Office of The Superintending
Engineer,
Designs (R & B) Circle,
Bl:13, 2nd Floor,
Dr.Jivraj Mehta Bhavan,
Gandhinagar-382010.
Date 29-08-2023

**Sub: PROPOSED 2- LANE RAILWAY OVER BRIDGE IN LIEU OF LC NO. 48A
BETWEEN RLY KM. 629/3 TO 629/4, NEAR DHRANGADHRA RLY. STATION,
DHRANGADHRA.**

looking into urgency this office has scrutinized GAD of the said work, the General Arrangement and technical provisions in the GAD (Drg no. ROB-DHRANGADHRA - 01) of the bridge proper is generally found in the order. However, Dimensions of various structural components may vary during detailed design as per design parameter.

TITLE					
GENERAL ARRANGEMENT DRAWING FOR RAILWAY PORTION.					
DRAWN BY : DHARMESH		DESIGNED BY : D. K. PARIKH		CHECKED BY : A. N. P.	
SIGN :		SIGN :		SIGN :	
DORC. NO : ROB - DHRANGADHRA - RLY - GAD - 01				SHEET :

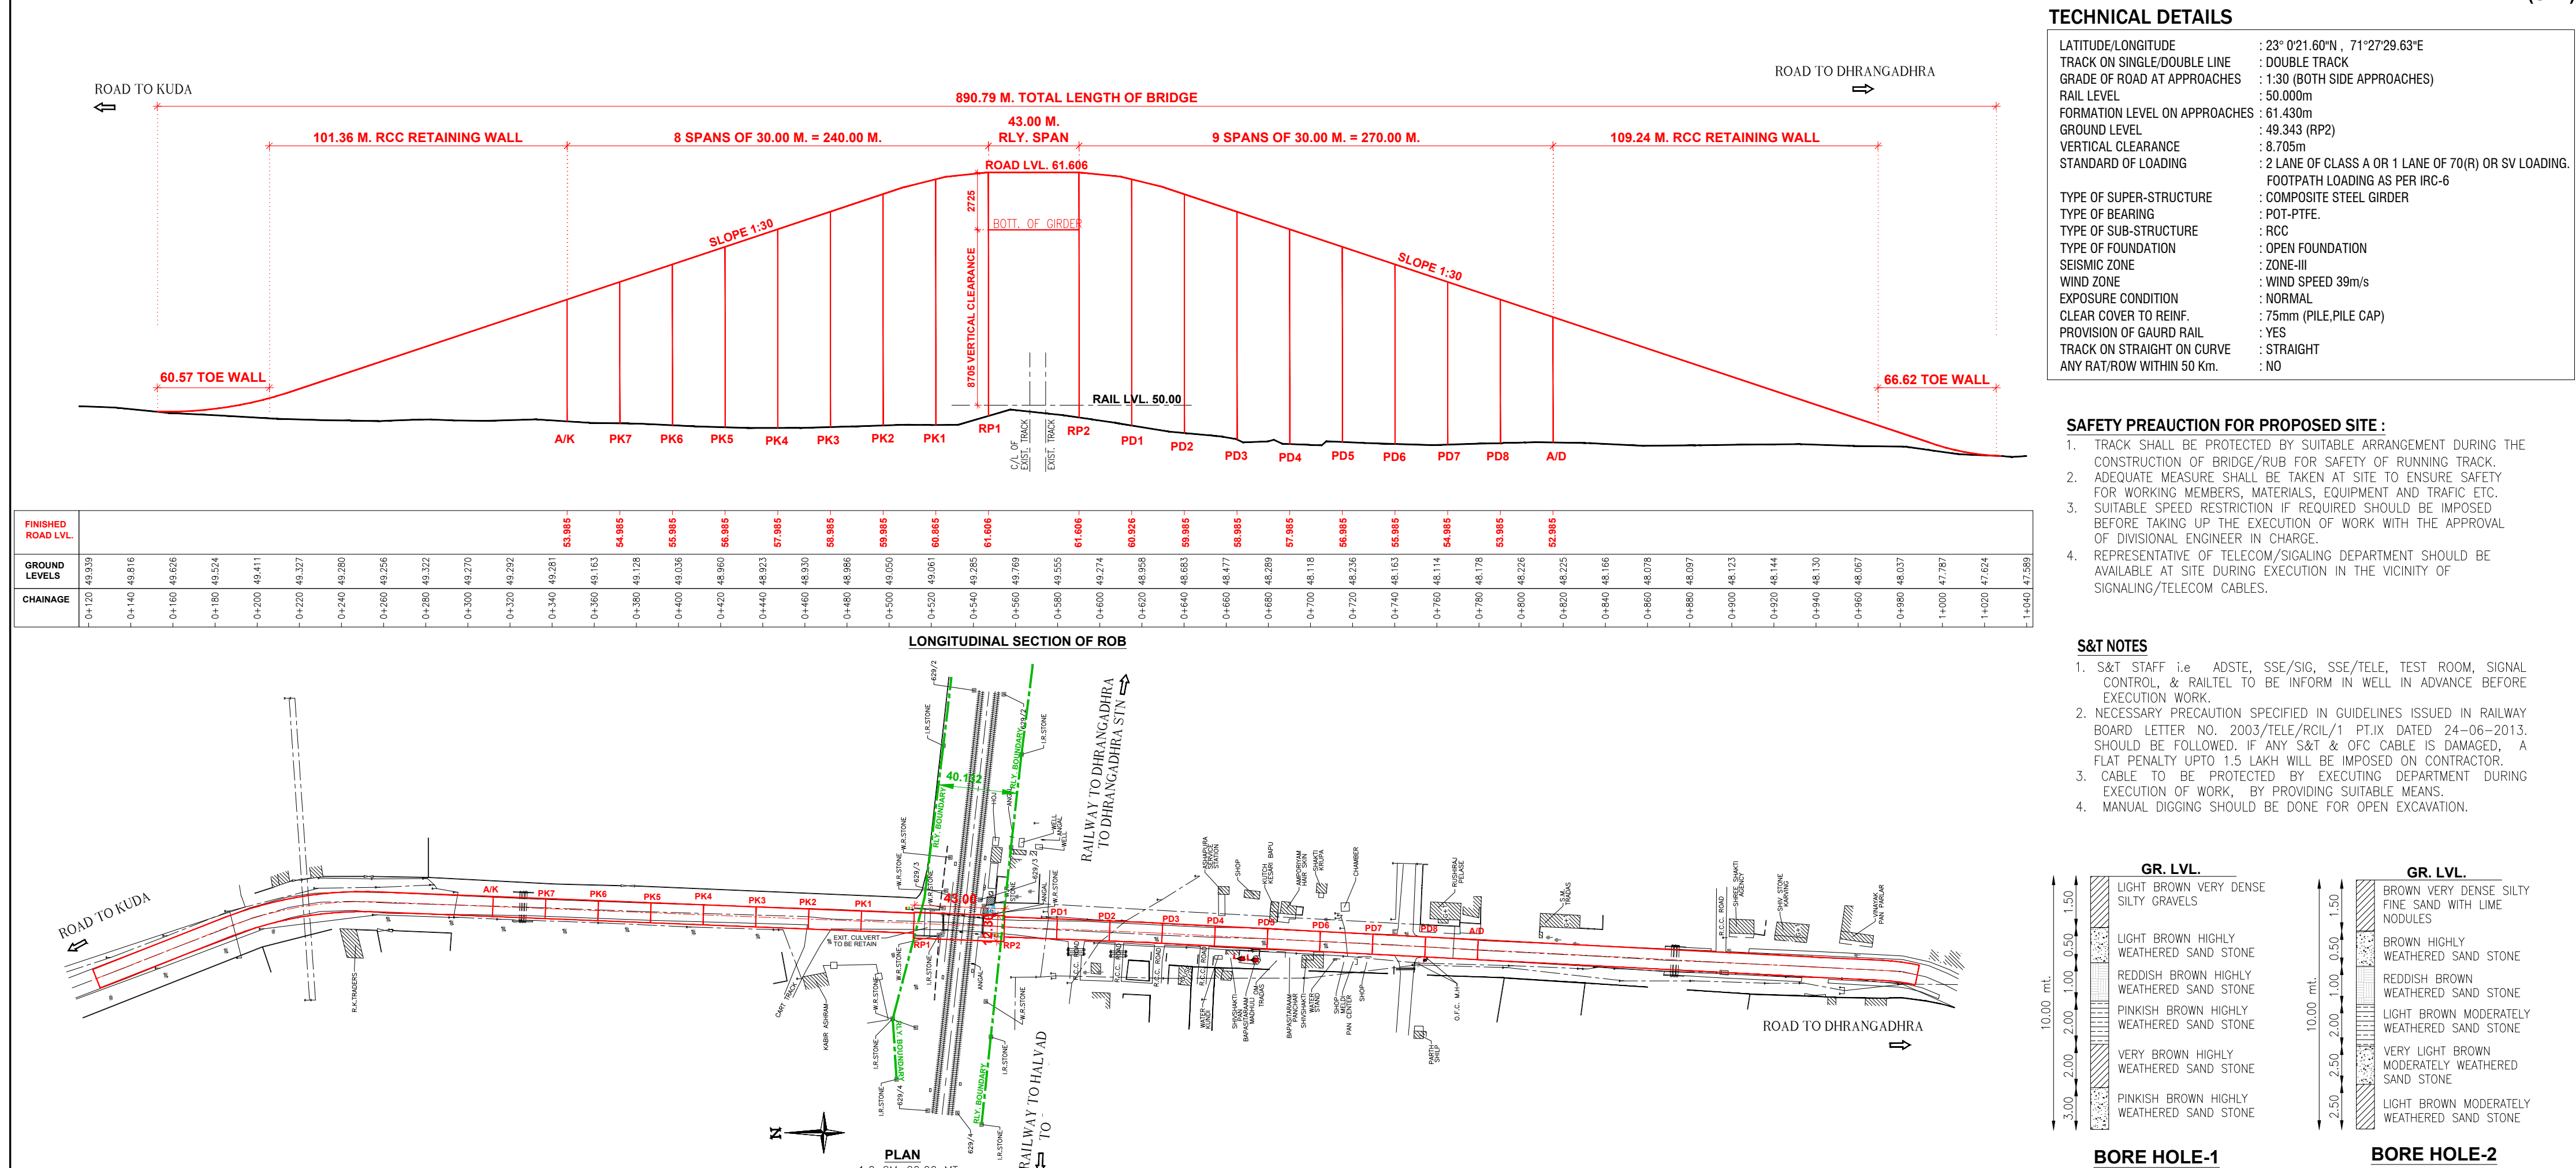
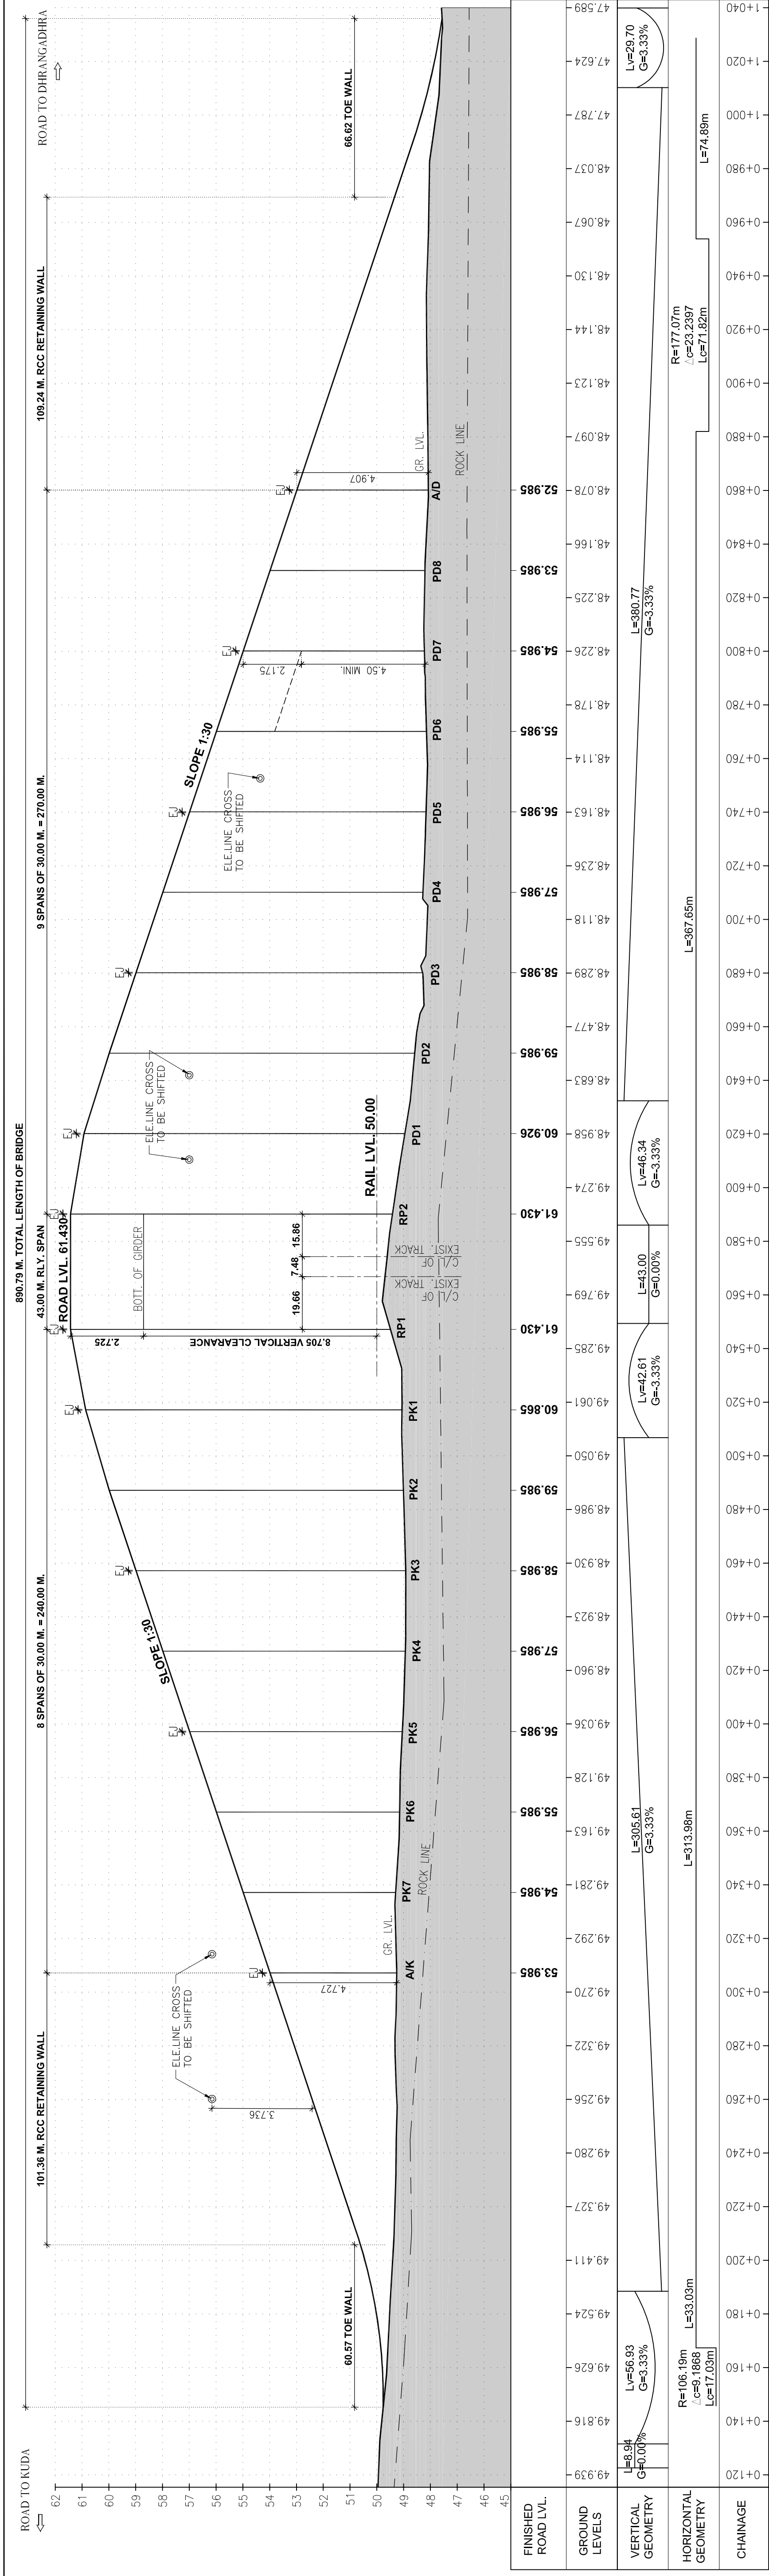
However, certain details shall be confirmed by GUDC Ltd. Gandhinagar before tendering.

1. Gradient of Approaches for ROB shall be preferably kept as 1:40 as per IRC:73 codal provisions with its latest amendment. However, steeper gradient up to permissible limit may be considered by GUDC Ltd. Gandhinagar as per specific site constraints.
2. Details of all type of utility and cross drainage work should be marked in GAD and submit separate drawing including all obstructions with ROW limit.
3. In curved span extra widening and super elevation should be provided as per IRC – 86 codal provisions with its latest amendment.
4. Bridge alignment shall be provided as per IRC codal provisions & seismic analysis of the bridge shall be done as per IRC SP 114- 2018 with its latest amendment.
